**ADDENDUM NO. 3**  
To the Contract Document and Project Specifications for the  
**JEFFERSON MIDDLE SCHOOL SITE IMPROVEMENTS**  
**Fort Wayne Community Schools (FWCS)**  
**Fort Wayne, Indiana**  
**January 7, 2025**

JEFFERSON MIDDLE SCHOOL  
PICKUP LANE  
FORT WAYNE COMMUNITY SCHOOLS  
FORT WAYNE, INDIANA  
1200 S CLINTON STREET

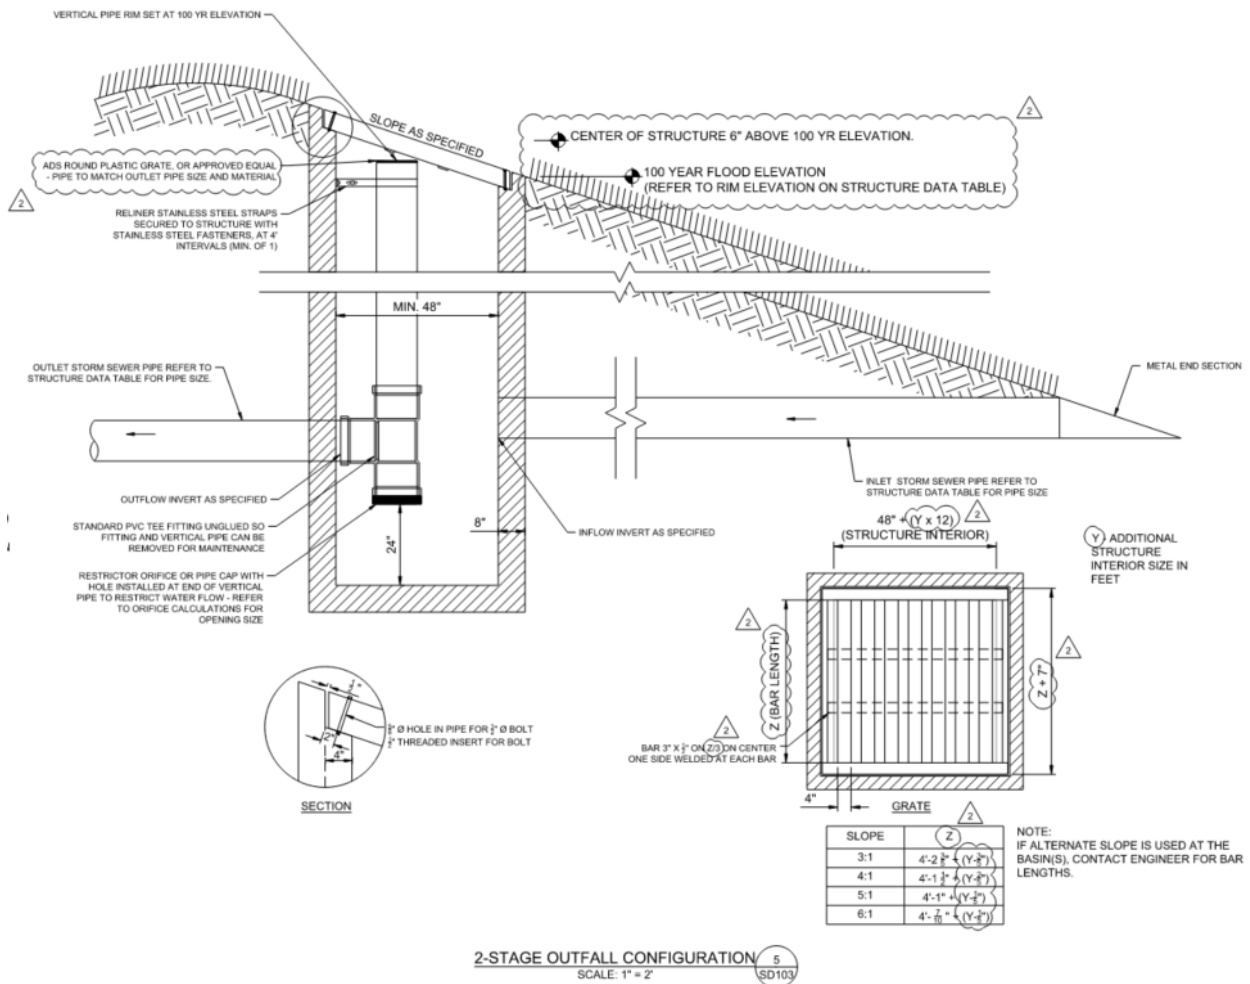
1. Plan Sheet C101 (Replace – See Attached Sheet)
  - A. **REVISED:** to include full sheet showing revisions from previous Addendum #2.
2. Plan Sheet C201 (Replace – See Attached Sheet)
  - B. **REVISED:** to include full sheet showing revisions from previous Addendum #2.
3. Plan Sheet C301 (Replace – See Attached Sheet)
  - C. **REVISED:** information related to STM-1 in the ‘New Storm Structure Information’ table.
4. Plan Sheet SD103
  - A. **REVISED:** Detail 5 to provide additional clarity on the 2-stage outfall configuration (see image on next page).

DESIGNED BY: JPR TEAM  
REVIEWED BY: NSD  
DRAWN BY: JPR TEAM  
REVIEWED BY: NSD  
DATE: DEC 09, 2024  
JOB NUMBER: 2024-01328  
HORIZ. SCALE: 1" = 20'  
VERTICAL SCALE: N/A  
**C101**

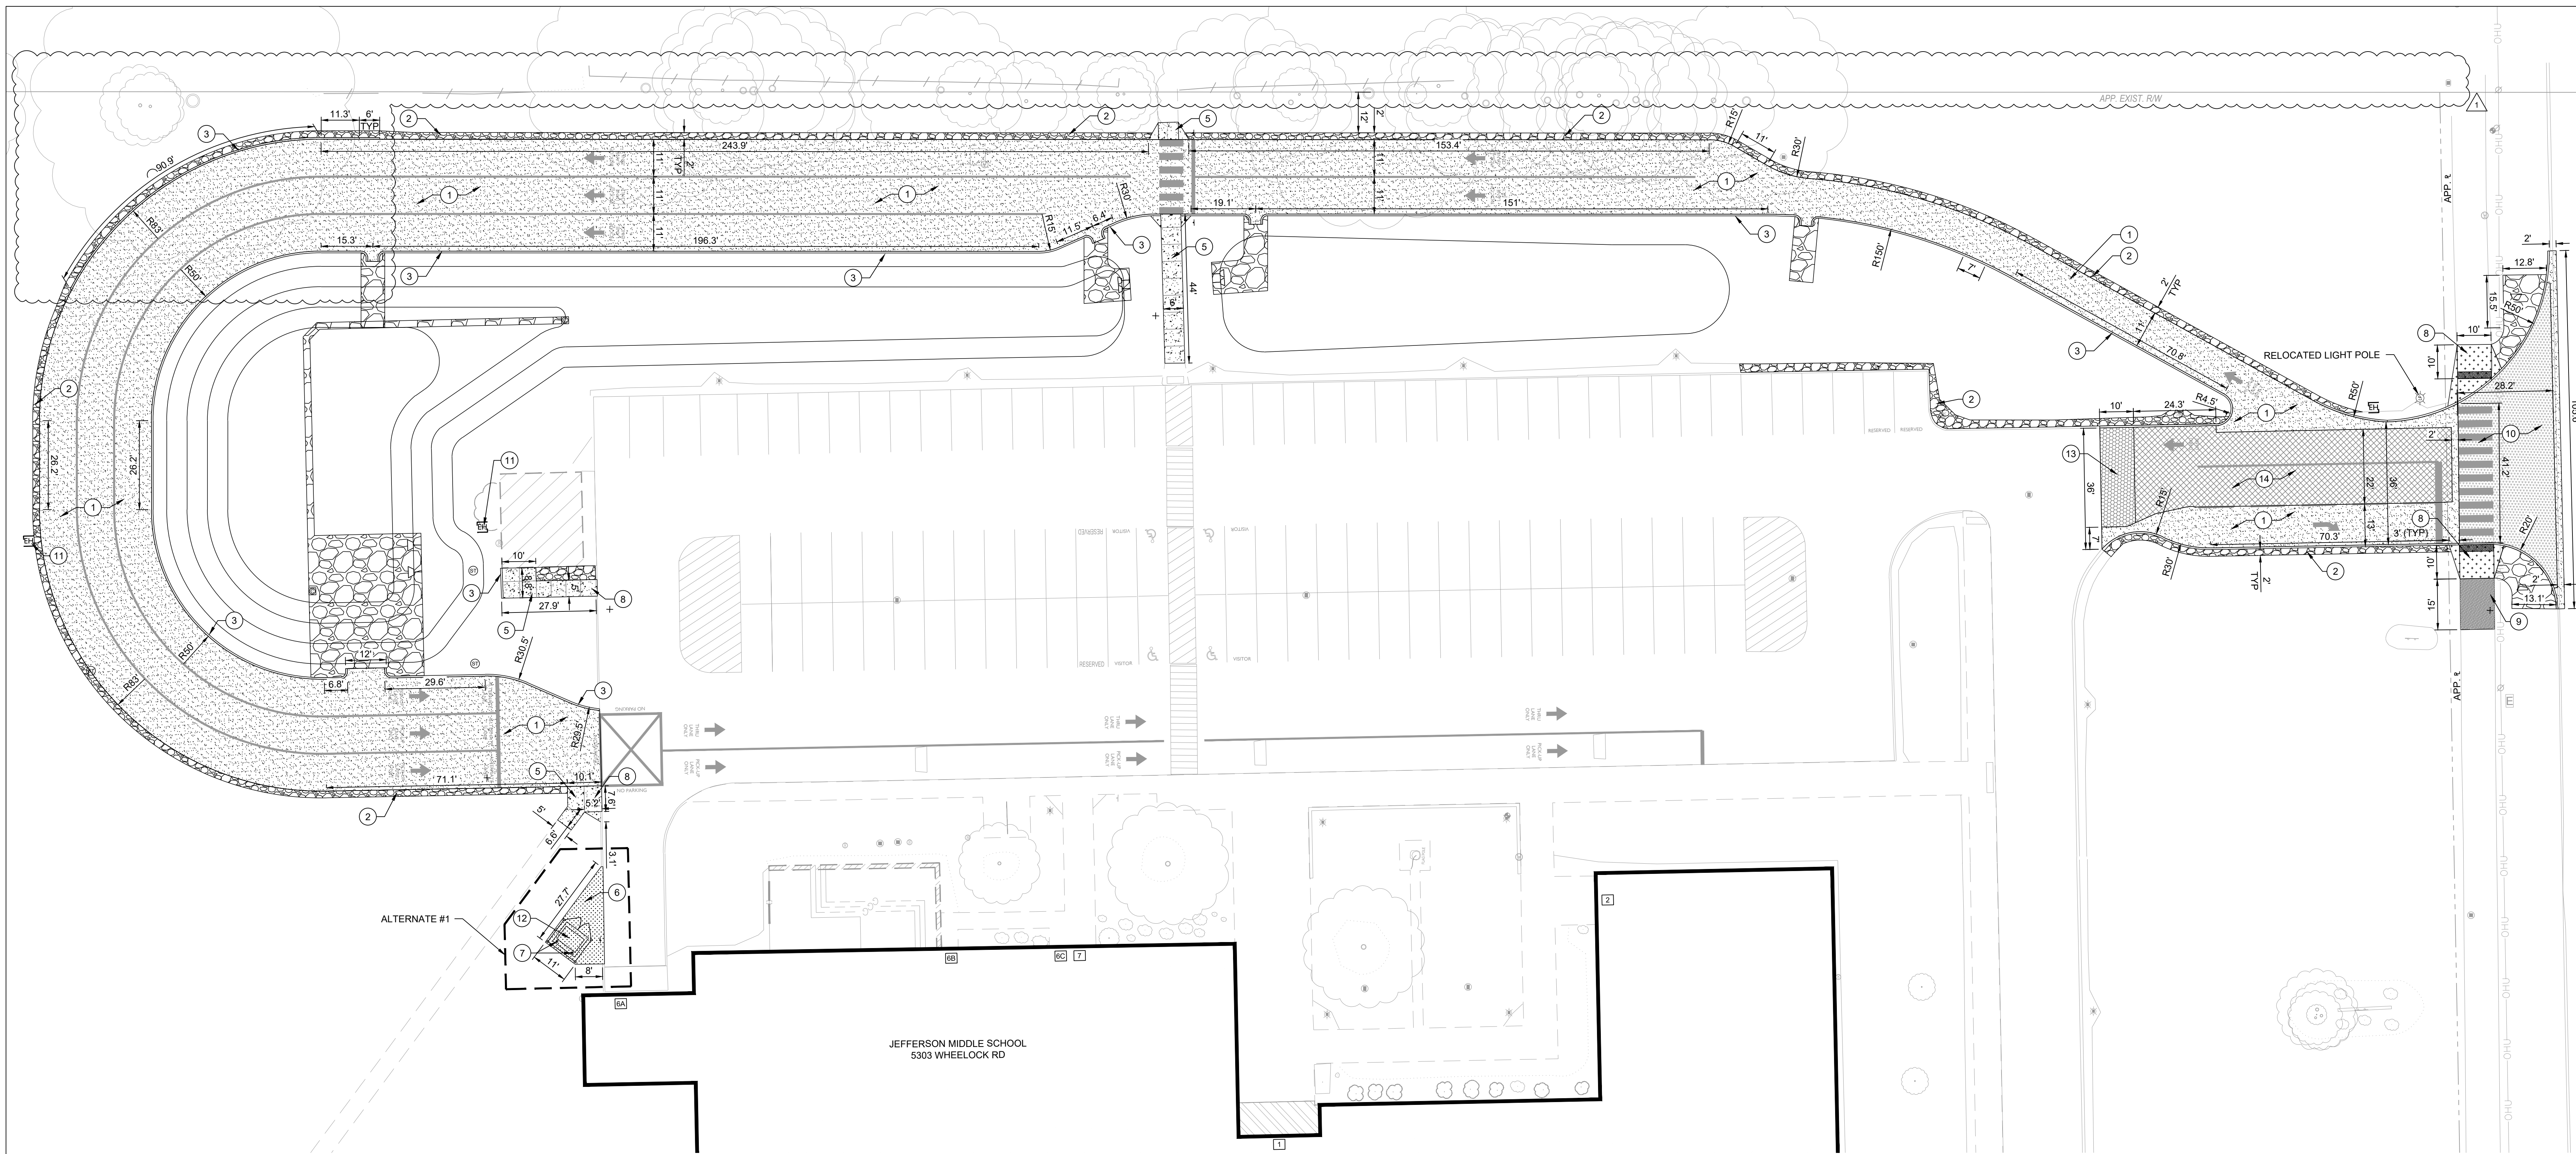
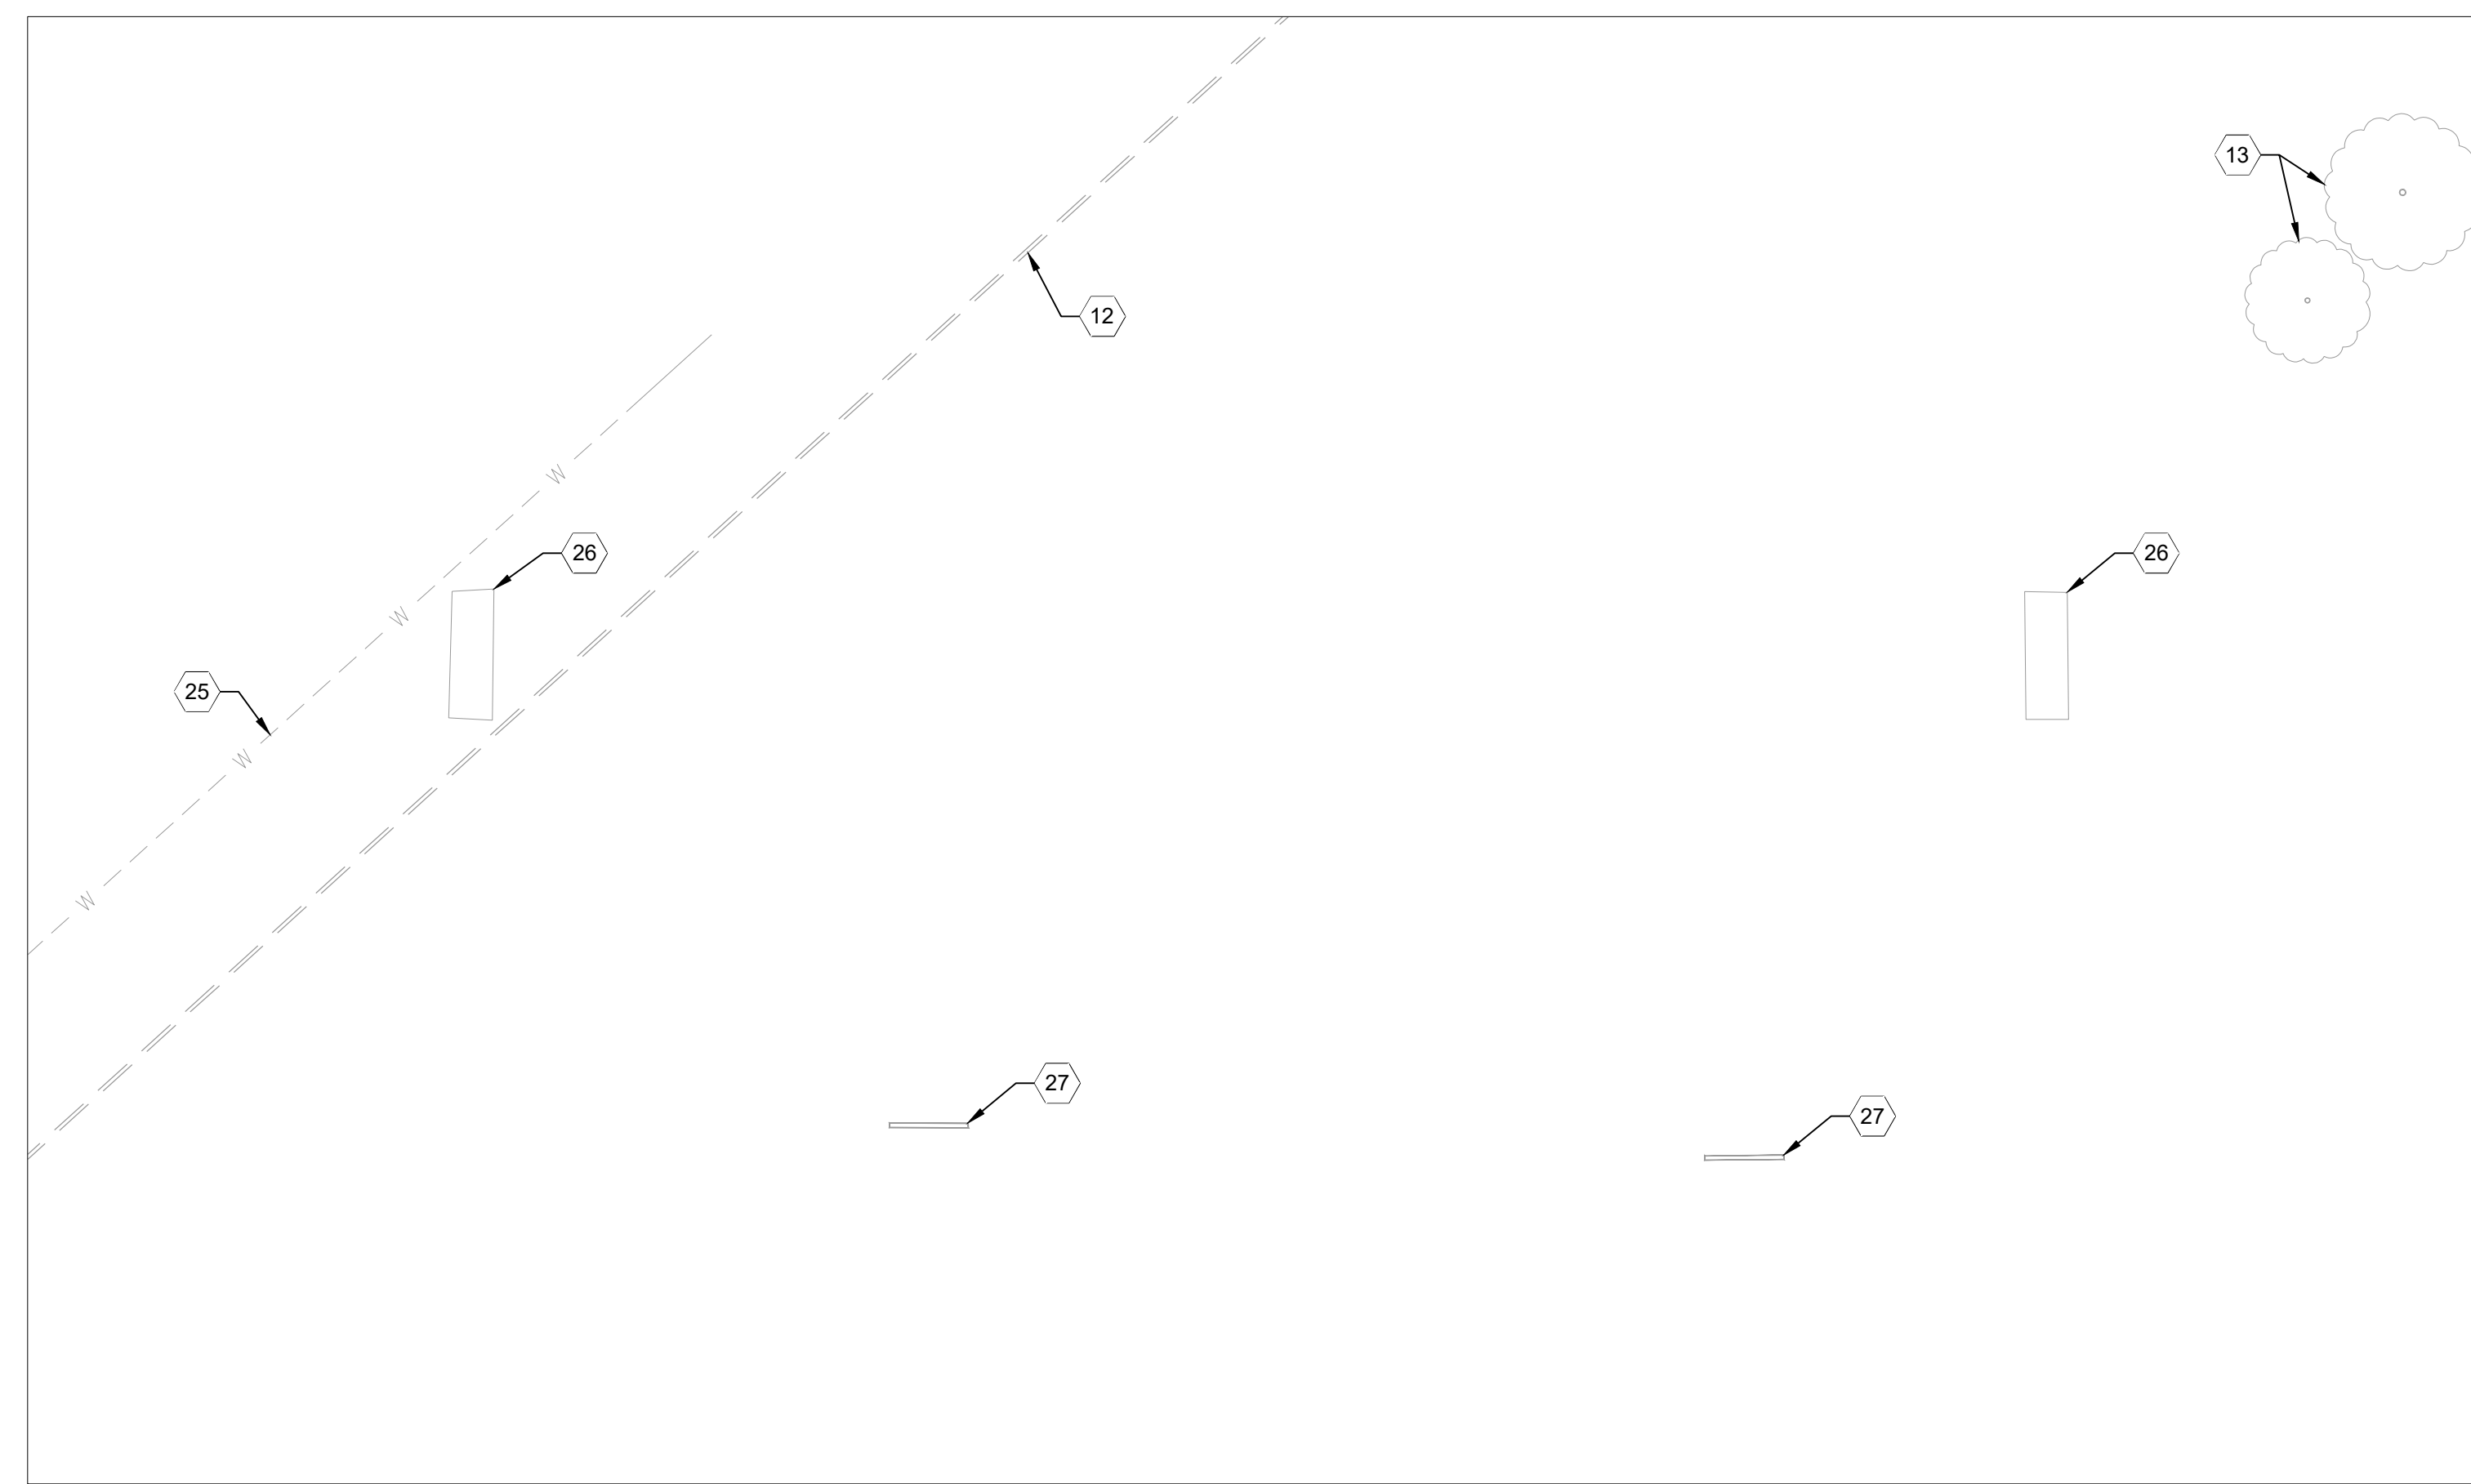
2. On sheet C101 under general notes on item #5, you state that FWCS will locate all known private utilities. On item #7 you state that the contractors should locate all private utilities not covered by the public locating service. Is FWCS going to perform this scope of work or do we need to hire a firm to perform this scope of work? If we need to perform this scope of work will FWCS provide any information they have on their private utilities?
  - A. FWCS is available to locate all known private utilities. The contractor shall contact FWCS a minimum of 48 hours in advance (Travis Searles, 260-438-0122). See note #3 on G101 under the Utility Notes. The contractor would be responsible for identifying any unknown utilities.

**C301**

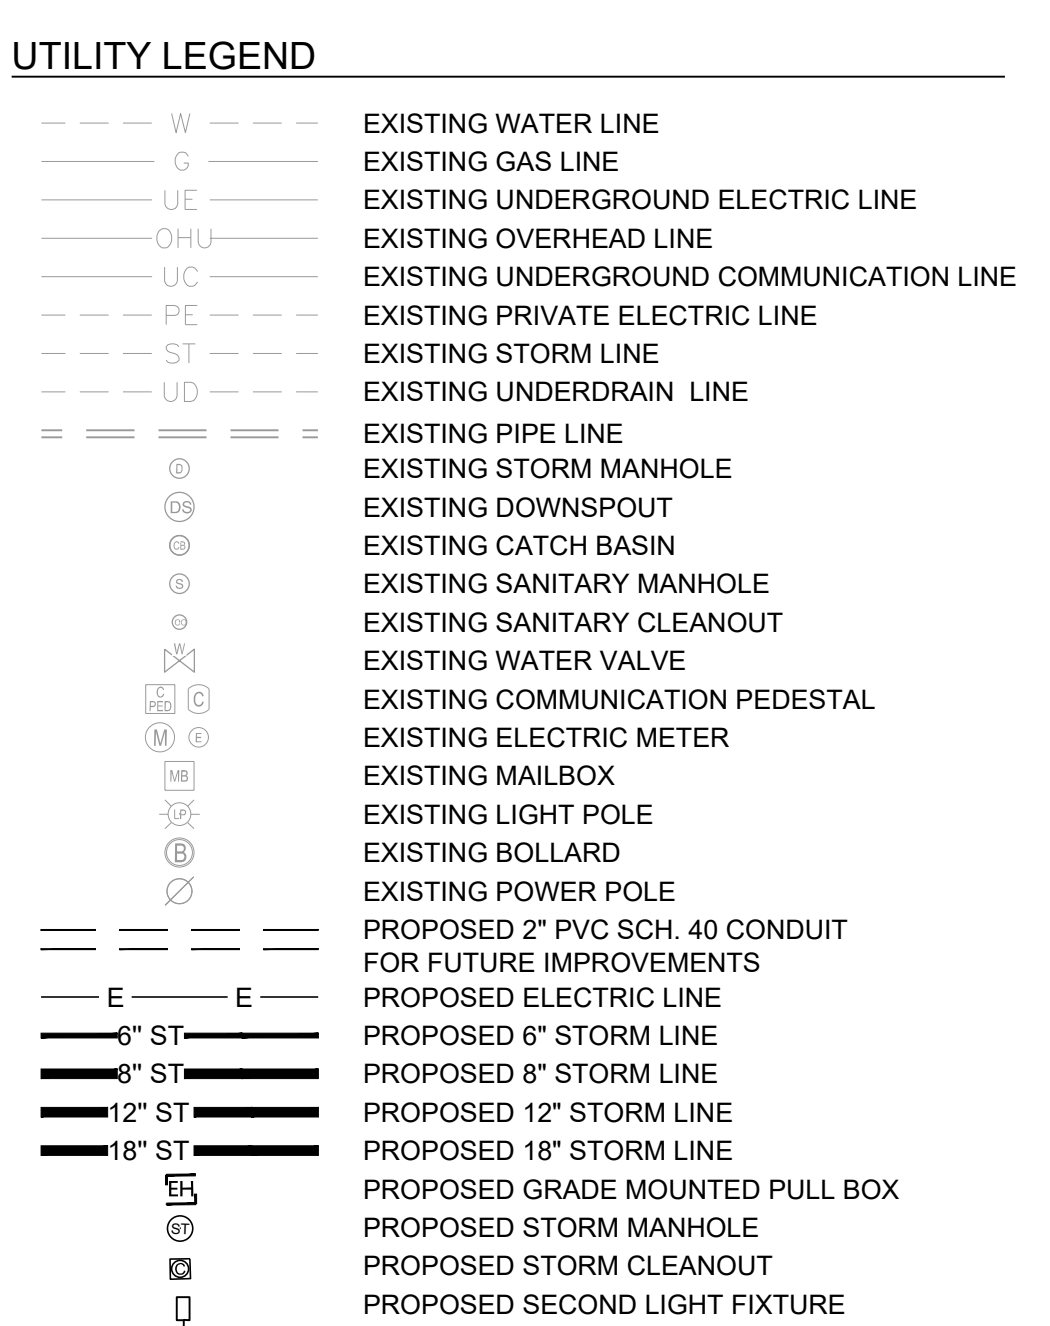
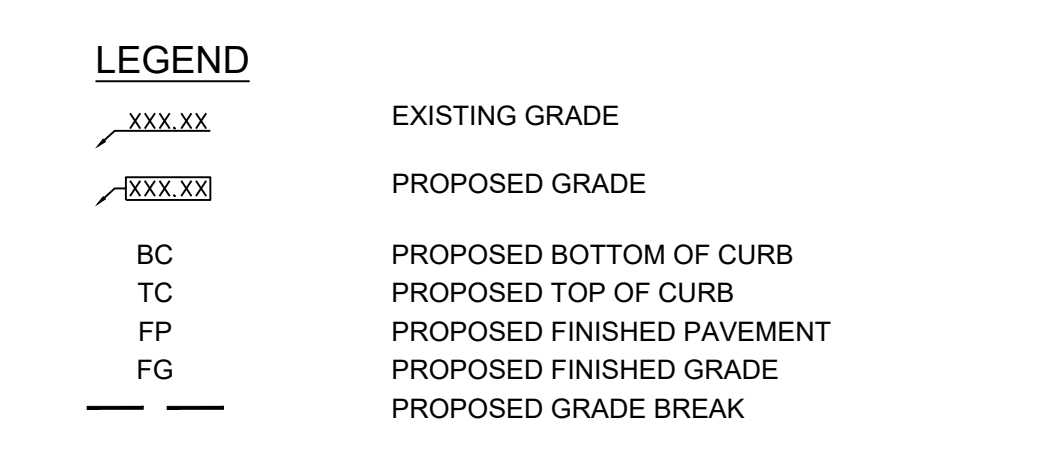
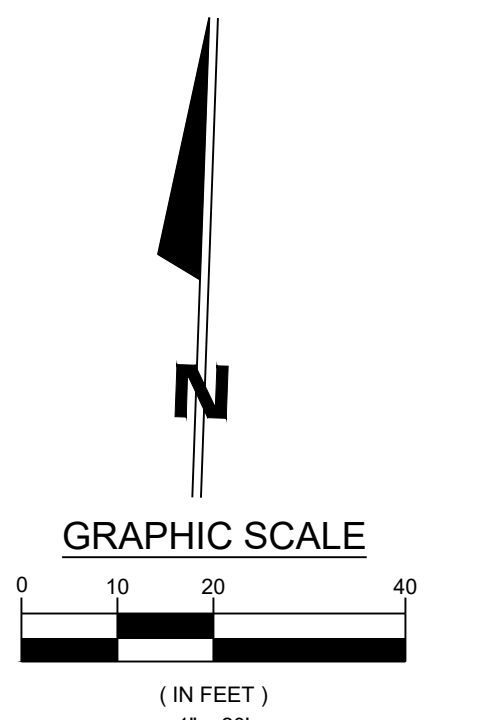
4. On the 2-Stage Outfall Configuration Structure is the riser made up of 18” materials? If so a 48” manhole will not give us enough room to install or to perform maintenance. Would you consider upsizing the structure to a 72” structure? This would provide a lot of room to maintain and remove the fitting in the future for maintenance.
  - A. *Thank you for bringing this to our attention. The plans have been revised within this addendum to incorporate a 72” structure and note the pipe size of riser is to match the outlet pipe, see the revisions on sheet C301 and SD103.*

STM-1 (72"x72") STORM MANHOLE SEE DETAIL 5/SD103 (RIM 786.00) INV 783.52 - 12" HDPE W INV 783.42 - 18" HDPE S (2-STAGE OUTFALL OUTLET PIPE)	STM-3 - 48" STORM MANHOLE, TYPE C RIM 790.35 INV 783.84 - 18" HDPE E INV 783.84 - 18" HDPE SW
STM-2 - 60"x60" STORM MANHOLE, TYPE C RIM 788.50 INV 783.26 - 18" HDPE N INV 783.16 - 18" HDPE W INV 783.16 - 18" HDPE E
